File No. LDA12-0341

RE: Tentative plan of subdivision to create 91 single detached residential lots, 6 semi-detached residential lots and 52 row housing lots from the SW 5-52-23-4 located east of 17 Street NW and north of 23 Avenue NW; **TAMARACK**

I The Subdivision by Plan is APPROVED on November 21, 2013 subject to the following conditions:

SUBDIVISION CONDITIONS OF APPROVAL MAP

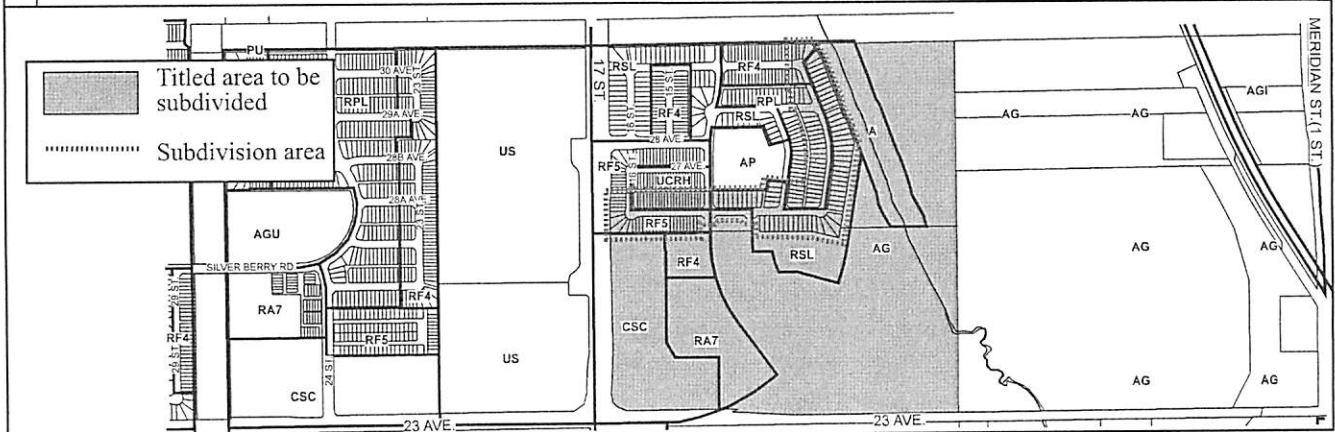
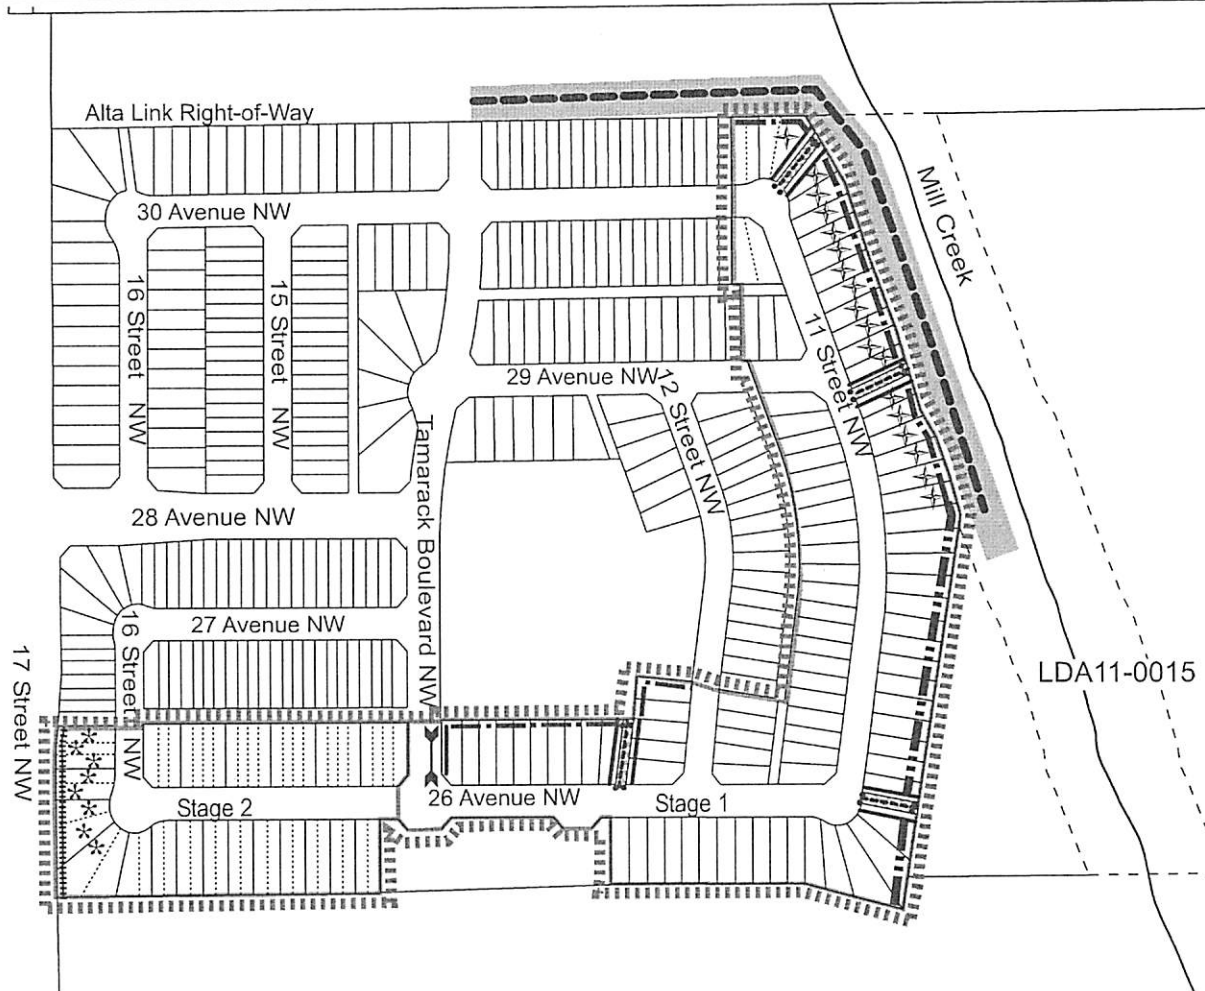
5. that the owner prepare a restrictive covenant in favour of the City of Edmonton that will be registered against the lots backing onto 17 Street NW, to protect the integrity of the berm and fence, as shown on the "Conditions of Approval" map, Enclosure I;

6. that the owner prepare a top-of-bank restrictive covenant in favour of the City of Edmonton that will be registered against the identified lots as shown on the "Conditions of Approval" map, Enclosure I;

7. that the owner be permitted to register this plan of subdivision in stages, as shown on the "Conditions of Approval" map, Enclosure I, at the discretion of the Chief Subdivision Officer, having regard to the provision of roadways and the logical extension of services;

11. that the owner construct noise attenuation in accordance with the requirements outlined in the Noise Study, for all lots backing onto 17 Street NW (at minimum a 1m berm and 1.8m noise attenuation fence, Drawing No. 5205 of the City of Edmonton's Roadway Design and Construction Standards, or combination thereof), to the satisfaction of Transportation Services as shown on the "Conditions of Approval" map, Enclosure I;

12. that the owner construct noise attenuation in accordance with the requirements outlined in the Noise Study, for all lots backing onto 23 Avenue NW (at minimum a 1.8m noise attenuation fence, Drawing No. 5205 of the City of Edmonton's Roadway Design and Construction Standards), to the satisfaction of Transportation Services as shown on the "Conditions of Approval" map, Enclosure I;

13. that the owner construct an extension of the 2m mono-walk with straight faced curb and gutter along Tamarack Boulevard, south of the park site to the bus stop and amenities pad, to the satisfaction of Transportation Services as shown on the "Conditions of Approval" map, Enclosure I;

14. that the engineering drawings include a 3m hard surface shared use path within the Alta Link right-of-way, with a dividing yellow centerline and "Shared Use" signage, lighting, bollards and landscaping, to the satisfaction of Transportation Services as shown on the "Conditions of Approval" map, Enclosure I;

15. that the engineering drawings include a 3m hard surface shared use path within the top-of-bank setback area, with a dividing yellow centerline and "Shared Use" signage and landscaping, to the satisfaction of Transportation Services as shown on the "Conditions of Approval" map, Enclosure I;

16. that the owner construct 1.5m sidewalks with lighting and bollards in the locations as shown on the "Conditions of Approval" map, Enclosure I;
17. that the owner construct all fences positioned wholly on privately-owned lands to the satisfaction of the Sustainable Development, Transportation Services and Financial Services and Utilities in the locations as shown on the "Conditions of Approval" map, Enclosure I; and

SUBDIVISION CONDITIONS OF APPROVAL MAP

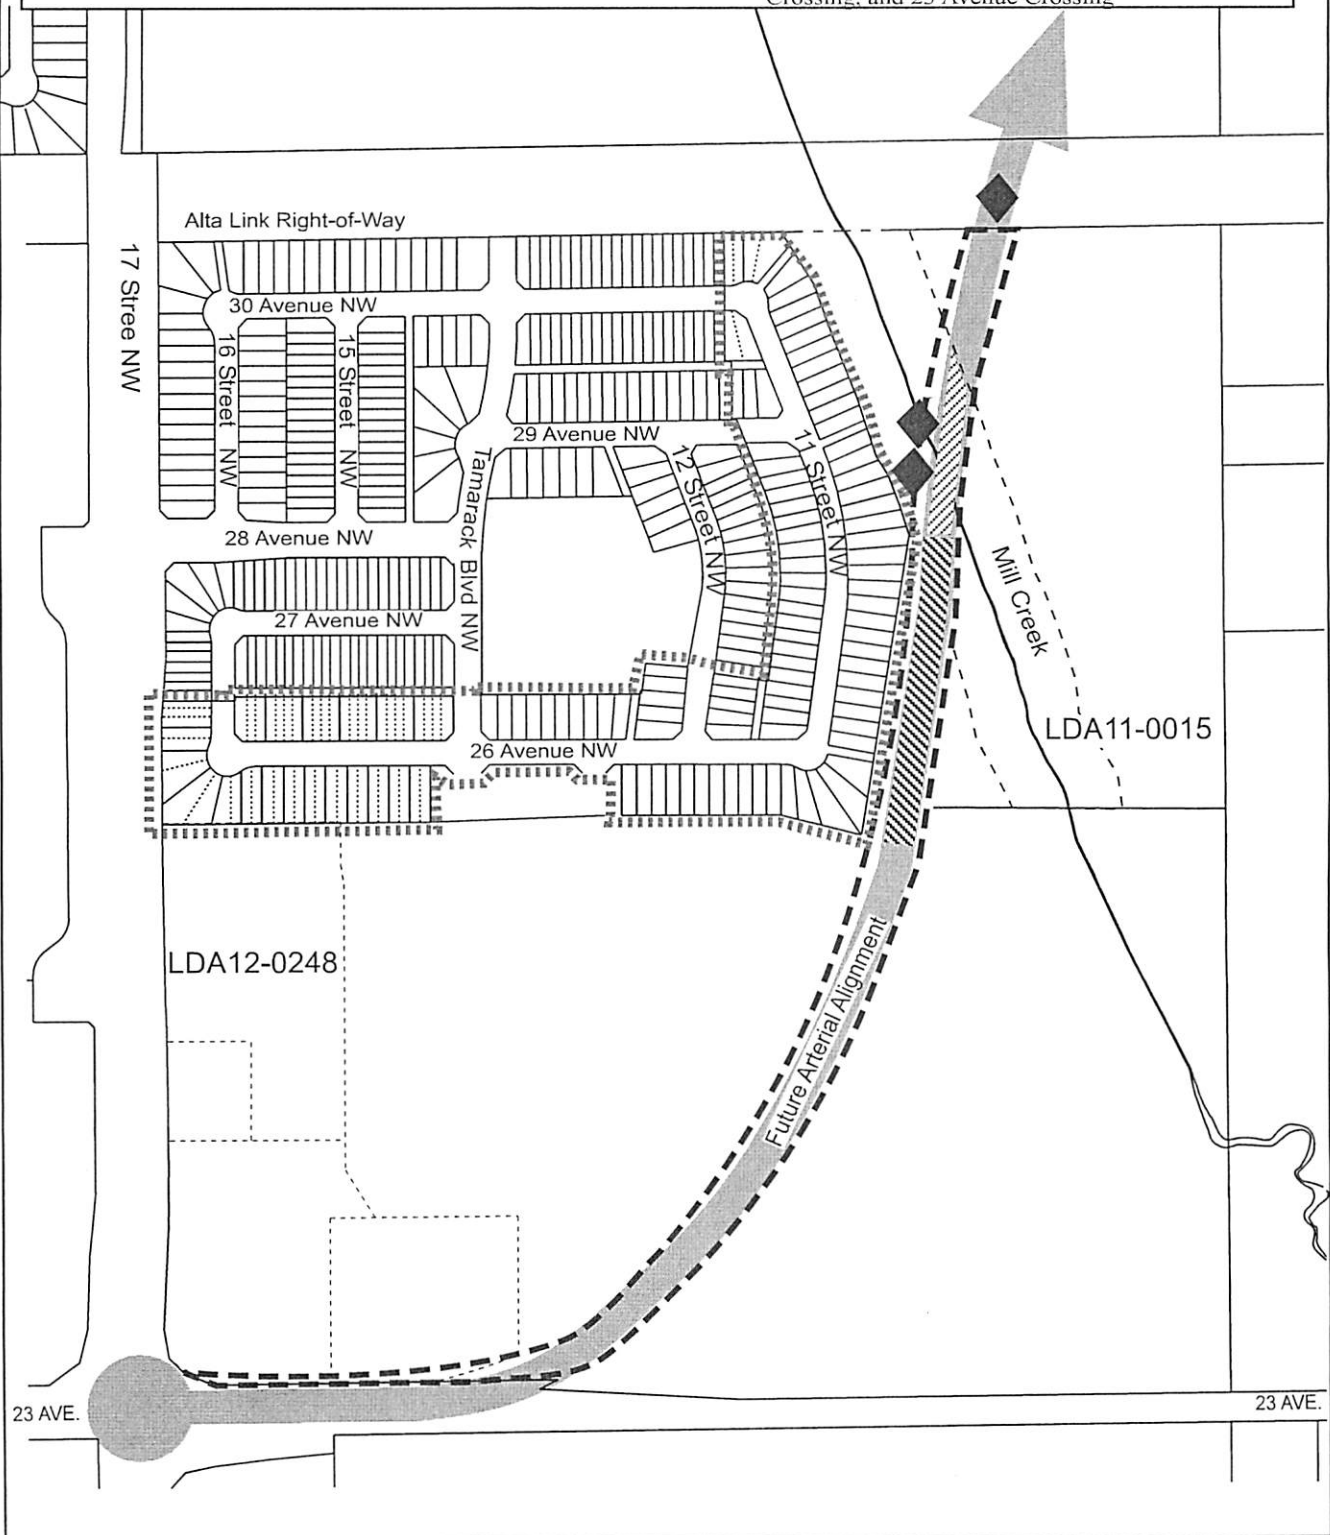
9. that the subdivision boundary be amended to include the dedication of 23 Avenue, to conform to an approved Concept Plan, or to the satisfaction of Transportation Services, as shown on the "Conditions of Approval" map, Enclosure II;
10. that subject to condition I.9, the owner clear and level 23 Avenue as required for road right-of-way dedication to the satisfaction of Transportation Services, as shown on the "Conditions of Approval" map, Enclosure II;
11. that the owner provide all walkways as road right-of-way as shown on the "Conditions of Approval" map, Enclosure I; and
12. that the owner pay all outstanding property taxes prior to the endorsement of the plan of subdivision.

7. that the owner submit updated Concept Plans for developing 23 Avenue NW to a four-lane urban divided arterial standard, from 17 Street to the TUC limit, to the satisfaction of Transportation Services, as shown on the "Conditions of Approval" map, Enclosure II;

8. that subject to condition II.7, Preliminary Plans are provided for 23 Avenue NW and include the creek crossing at Mill Creek and details of the top-of-bank walkway connection to the 23 Avenue walkway system as well as 23 Avenue crossing, to the satisfaction of Transportation Services, as shown on the "Conditions of Approval" map, Enclosure II;

9. that the engineering drawings include the grading plans for 23 Avenue NW adjacent to the subdivision if the 23 Avenue Preliminary Plans are not approved at the time of engineering drawing submission, to the satisfaction of Transportation Services, as shown on the "Conditions of Approval" map, Enclosures I and II;
